Re: Willow Creek EA – Layout Update

On January 4, 2014, Wind Quarry, LLC (“**Wind Quarry**”) submitted an interconnection request to the Western Area Power Administration (“**WAPA**”) to connect its proposed Willow Creek Wind Energy Facility (the “**Project**”), a 103.5-megawatt (“**MW**”) nameplate capacity wind energy facility in Butte County, South Dakota, to WAPA’s Maurine to Rapid City 115-kilovolt (“**kV**”) transmission line. Interconnection would be at a new switchyard to be constructed by WAPA and located within the Project Area.

**WILLOW CREEK
WIND PROJECT**
BUTTE COUNTY, SOUTH DAKOTA

ROAD LAYOUT OPTIONS
44 / 45 WTD LAYOUTS

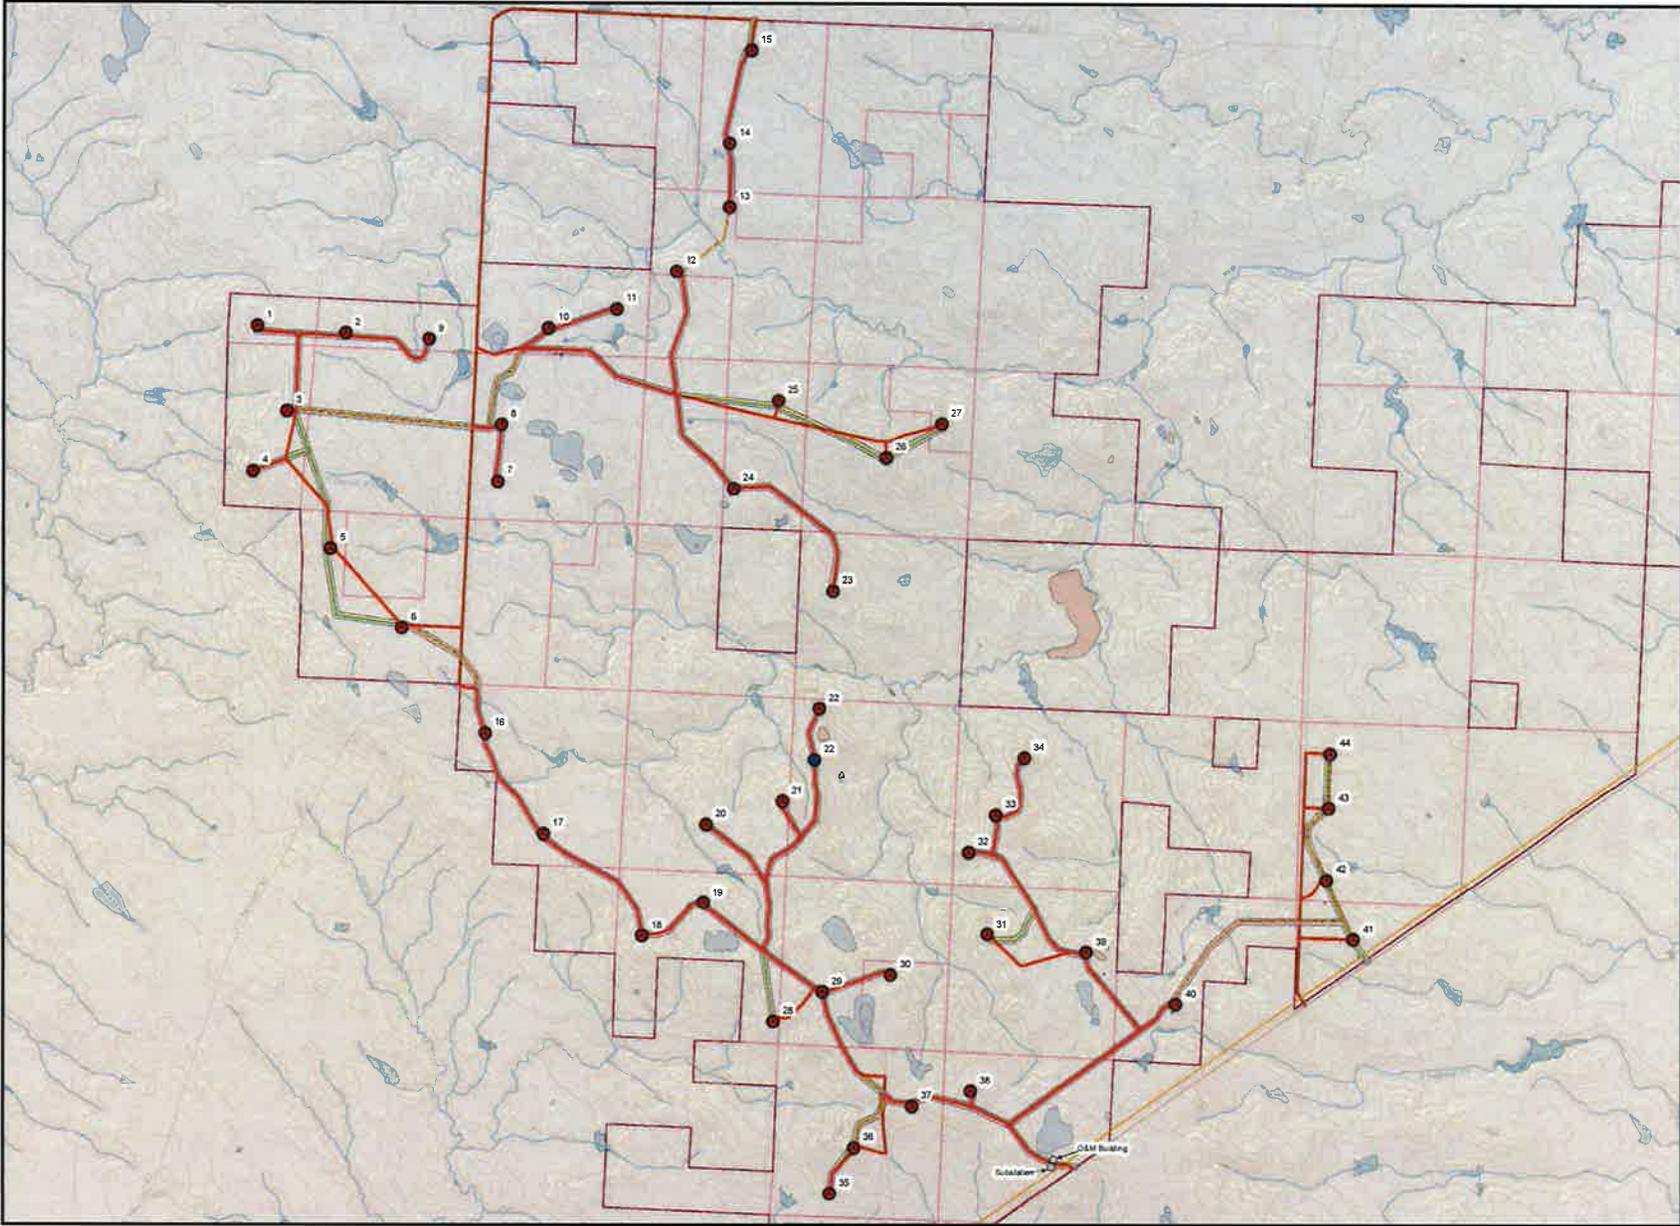
As mentioned, under any of the three proposed turbine combination scenarios, turbines would be located at the same locations as presented in the EA. However, because of the larger rated capacity of the individual turbines, fewer turbine locations would be utilized (38, 42, or 44 turbine locations depending on the scenario) to achieve approximately the same overall Project rated capacity. The figures in Appendix A show the Project layout under each of the three scenarios, as compared to the original 45-turbine layout.

In addition to the proposed changes in turbine type, Pattern is proposing a revised electrical collection line and access road layout. The collection and road layouts differ slightly under each scenario, as shown on the figures in Appendix A. Two figures are included for each scenario – one showing access roads and one showing the collection lines. A breakdown of temporary and permanent disturbance under each of the three proposed scenarios, as compared to the original 45-turbine layout, is included in Appendix B.
